Service Bulletin M-954

October 30, 1987

New Big Twin Crankcase Breather Gear

Figure 1. Comparison of Crankcase Breather Gears

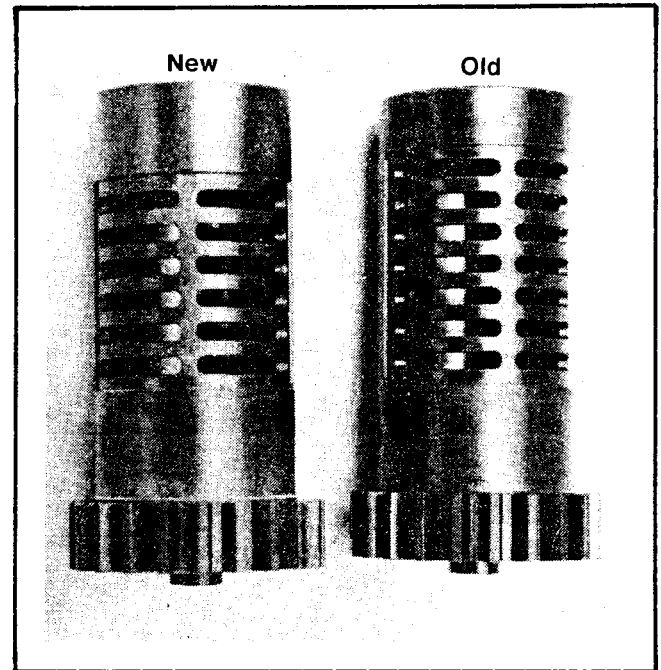
The new design better accomodates slight variations in oil hole position that occur during manufacture of the crankcases.

In rare situations on earlier shovelhead and evolution engines, where there is a small amount of oil carry-over (mist) into the air cleaner, the new breather gear may stop oil misting.

See figure 1. The new breather gear window has one less row of slots (were 7, are now 6).

The new Part Number is 25313-77C.
